SUBJECT: Responds to RAI re TS amend request, allowing laser welded repair of Westinghouse hybrid expansion joint sleeved SG tubes.

Docket 50-305
Operating License DPR-43
Kewaunee Nuclear Power Plant
Response to Request for Additional Information on Laser Welded Repair
Technical Specification Amendment Request

**Response to Request For Additional Information
On Proposed Laser Welded Repair of HEJ Sleeved Tubes**

Figure 1 Cross section of LWS weld WP 06 without contaminant. Mag. 40X.

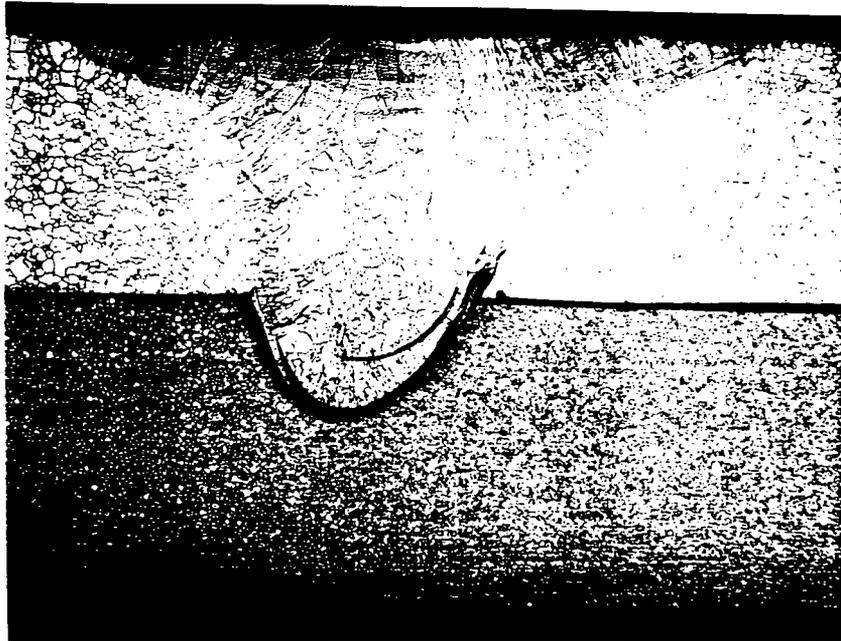
Please provide a discussion (with complete photomicrographs) of the microstructural differences between laser welds for a new sleeve (LWS) and the laser weld repair (LWR) of an ex-service or laboratory aged mock-up. Include comparative weld joint tensile strength test results for LWS versus LWR. Compare the failure morphologies.

A discussion on the microstructural differences between the laser welds for a new LWS and the LWR process on laboratory aged mock-ups was previously provided on October 25, 1996 in response to Question 3. Additional photomicrographs are included with this response. Figures 1 through 4 show a typical laser weld made with a clean tube and sleeve, and Figures 5 through 8 show typical cross sections for welds made after contaminating the sleeve tube interface.

A detailed examination of the new sleeve/tube laser welds and laser welds made with contaminants show no discernible differences. In both types of welds, the weld heat input with a pulsed laser did not result in coarsening of the grain size of the base metal near the fusion boundary. The different grain sizes of the tube metal in the two welds is because the samples used tubing materials from different heats and heat treatments. All welds were structurally sound with no cracks, lack of fusion, or porosity.
